UNITED STATES PATENT AND TRADEMARK OFFICE

10/582,018

Office Action Summary	Application No. 10/582,018	Applicant(s) FUJITA ET AL.	
	Examiner SEYED M. MALEKZADEH	Art Unit 1791

DETAILED ACTION

Fig. 5M

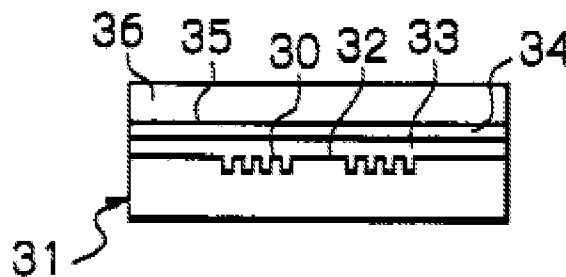
Murata et al. ('618) teach a stamper for molding an optical disk base in which the apparatus includes a mother portion (31) as a lower most section made of nickel (see lines 30-37, column 5), a nickel layer (36) as an uppermost section, and a middle section comprising a thick nickel layer (33) formed on the lower section (31) and a heat insulating layer (34) formed on the thick nickel layer (33). (See lines 38-61, column 5, also figure 5M) Therefore, the prior art teaches an uppermost section made of nickel, a lower most section, also, made of nickel, and a middle section having a heat conductivity lower than the upper most section and including a metal layer

as the same metal material as the uppermost section and the lowermost sections, and a heat insulating layer. Furthermore, Murata et al. ('618) disclose the heat insulating portions include heat resisting substances formed on the nickel layer. (See lines 53-59, column 2)

Murata et al. ('618) also teach the heat insulating layer is made of polyimide particles which is a heat resisting resin (See lines 47-59, column 4 and lines 40-43, column 8) and a heat resistant inorganic polymer. (See lines 59-67, column 8)

However, Murata et al. ('618) fails to teach heat resisting substances are dispersed in the metal material of the middle section, as claimed in claim 1, and the middle section is a matrix with a plurality of voids formed within the matrix, as claimed in claims 2 and 4.

Further, applicants argue that Murata does not have the claimed pattern on a surface thereof for use in molding an optical disc substrate and as can be seen from the figure (5M), includes both the mother portion (31) and the heat insulated stamper (21) (Fig. 5N). Thus, the heat insulating stamper (21) of Murata would more accurately correspond to the claimed heat insulating stamper.

This is not found persuasive because applicant's attention is drawn to the point that claim 1 indicates that heat insulating stamper comprises a structure of "an uppermost section", "a lower most section", and "a middle section" in which specifically recitation of "comprising" in the claim means the structure of the apparatus is capable of including further apparatus elements. As discussed above, in the body of the rejection, Murata et al. (US '618) in view of Kamitakahara et al (JP '075) teach all the structural limitations of a heat insulating stamper as claimed in claims 1-4 and 6-8, and if the recited references include more structural elements, it does not invalidate the capability of recited prior arts for the rejection. Therefore, rejection of claims 1-9 are maintained.

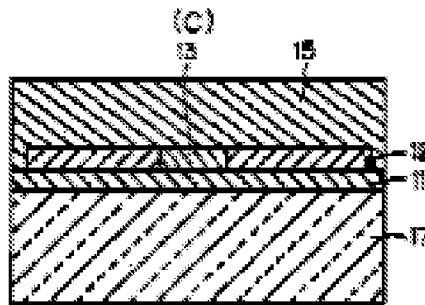
In the analogous art, Kamitakahara et al (JP 40520075) teach a roll stamper apparatus for forming concaves and convexes on a thermoplastic resin sheet as base material for optical information recording medium in which the apparatus comprises a flexible stamper (23) as an uppermost section, a heat insulating porous layer (22) as a middle layer, and a mirror

surface roller (21), as a lowermost section, in which the porous layer (22) is located between the stamper (23) and a mirror surface roller (21). (See abstract) Furthermore, the prior art teaches the air is dispersed within the voids of porous material of the middle layer (22) in which since thermal conductivity of the air is very small, air acts as a thermal break in the porous layer to provide an effective adiabatic efficiency. (See paragraph [0018]) Moreover, the prior art teaches the porous layer (22) is a layer of the homogenous thickness contained in a matrix material for example by using air as a closed cell or an open cell. (See paragraphs [0035] – [0036]) Furthermore, the prior art teaches through providing a porous layer, as a heat insulating layer, between a roll and a flexible stamper, the generation of uneven flaws or transfer irregularities in the fine pattern of the substrate for producing a data recording medium molded by a roll stamper is prevented. (See abstract; purpose of the invention)

Therefore, it would have been obvious for one of ordinary skill in the art at the time of applicant's invention to modify the heat insulating stamper apparatus as taught by Murata et al. ('618) through dispersing a plurality of minute voids as heat insulating substances in the matrix formed middle layer of the stamper apparatus in order to prevent the generation of uneven flaws or transfer irregularities in the fine pattern of the substrate for the data

【図1】

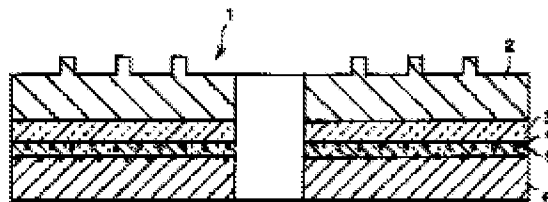
In the analogous art, Shibata (JP '450) teach a heat insulation stamper (1) comprising sequential lamination of a transfer metal layer (2), a heat insulation layer (3), and a metal layer (6) in which the insulation layer (3) and the metal layer (6) bonded through a coating layer (4) mixed with a filler (5) made of an inorganic material comprising oxidized silicon, an aluminum oxide, zirconium oxide, Nitrides, silicon carbide, zirconium carbide, and silicon nitride, or the mixture of these substances.

Therefore, it would have been obvious for one of ordinary skill in the art at the time of applicant's invention to modify teachings of the Murata et al. (US '618) and Kamitakahara et al (JP '075) through providing a heat resisting inorganic material inside of the insulating layer including zirconia series, alumina series, silicon carbides series, or silicon nitride series in order to improve durability of the heat insulation stamper and also to increase the strength of bonding between the insulation layer and the metal layer, as suggested by Shibata (JP '450).
